Access Compliance Report

Public Rights-of-Way

(Curb Ramps)

Intersection ID: 27628	Main Street: BALLANTYNE COMMONS PY	Cross Street: ADAIR MANOR CT	Location: NE
ADA ID: 4FC7266CFB0D	Ramp Type: Perp	Initial Pass/Fail: Fail	Overall Compliance: No
Severity Score: 8.75			
Codes/Mitigation Info/Possible Solution		Field Measurements/Component Compliance

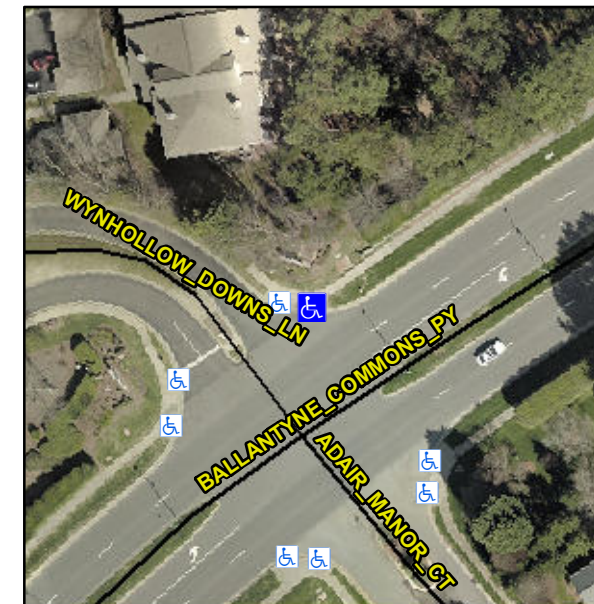
Not Found, R304.5.1

Compliance	Description	Data	Compliance	Description	Data
N/A	Ramp Length (in)	113.0	Yes	Ramp Slope (%)	5.7
No	Ramp Width (in)	40.5	Yes	Ramp XSlope (%)	1.9
N/A	Flare Type LT	N/A	N/A	Flare Type RT	N/A
N/A	Flare Slope LT (%)	N/A	N/A	Flare Slope RT (%)	N/A
N/A	Flare Traversable LT?	N/A	N/A	Flare Traversable RT?	N/A
N/A	Landing Length (in)	N/A	N/A	DWS Provided?	N/A
N/A	Landing Width (in)	N/A	N/A	DWS Contrast?	N/A
N/A	Landing Slope (%)	N/A	N/A	DWS Length (in)	N/A
N/A	Landing X Slope (%)	N/A	N/A	DWS Full Width?	N/A
N/A	Landing Curb? (Y/N)	N/A	N/A	DWS Offset (in)	N/A
N/A	Shared Landing?	N/A			
N/A	Gutter Ponding?	N/A	N/A	Gutter Slope (%)	N/A
N/A	Gutter Lip Ht (in)	N/A	N/A	Gutter X Slope (%)	N/A
N/A	Painted X Walk1?	No	N/A	Painted X Walk2?	N/A
	X Walk 1 Direction	To SE		X Walk 2 Direction	N/A
N/A	X Walk 1 Width (in)	N/A	N/A	X Walk 2 Width (in)	N/A
	X Walk 1 Slope (%)	2.4		X Walk 2 Slope (%)	N/A
	X Walk 1 X Slope (%)	1.9		X Walk 2 X Slope (%)	N/A

Remove & Replace Entire Ramp.
